Well Name: POKER LAKE UNIT 21 DTD	Well Location: T24S / R30E / SEC 21 / SWNE / 32.207389 / -103.882104	County or Parish/State: EDDY / NM
Well Number: 176H	Type of Well: CONVENTIONAL GAS WELL	Allottee or Tribe Name:
Lease Number: NMLC068431	Unit or CA Name: POKER LAKE UNIT	Unit or CA Number: NMNM71016X
US Well Number: 3001550199	Operator: XTO PERMIAN OPERATING LLC

Notice of Intent

Sundry ID: 2870322

XTO Permian Operating LLC respectfully requests to make the following changes for:

ACREAGE DEDICATION PLATS

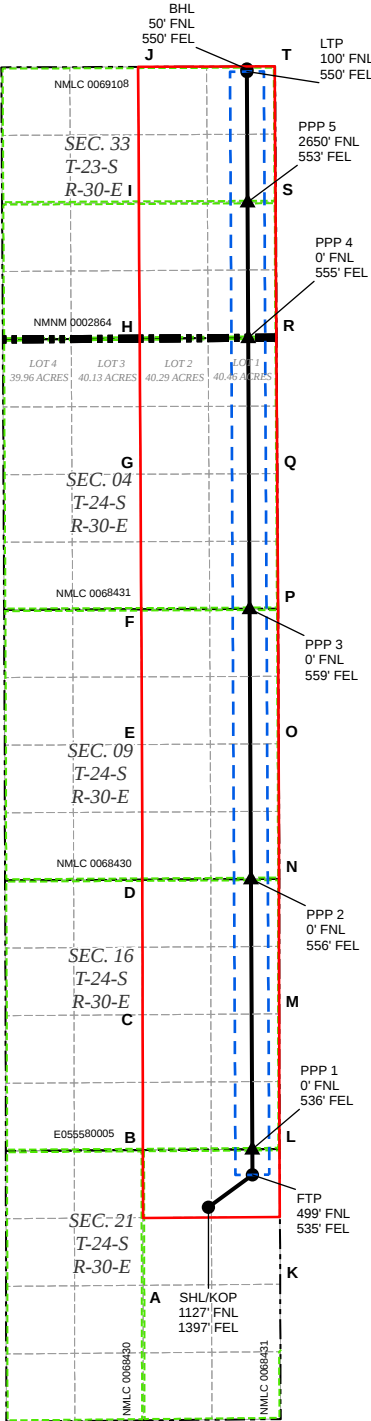
Dedicated acres: f/ 1280.75 t/ 1360.75

TD: f/ 33148 MD / 11292' TVD t/ 32954 MD/ 11293.7 TVD

FTP: f/ 100 FSL & 550 FEL t/ 499 FNL & 535 FEL, Sec 21-24S-30E; Lease NMLC 0068431

Updated HSU
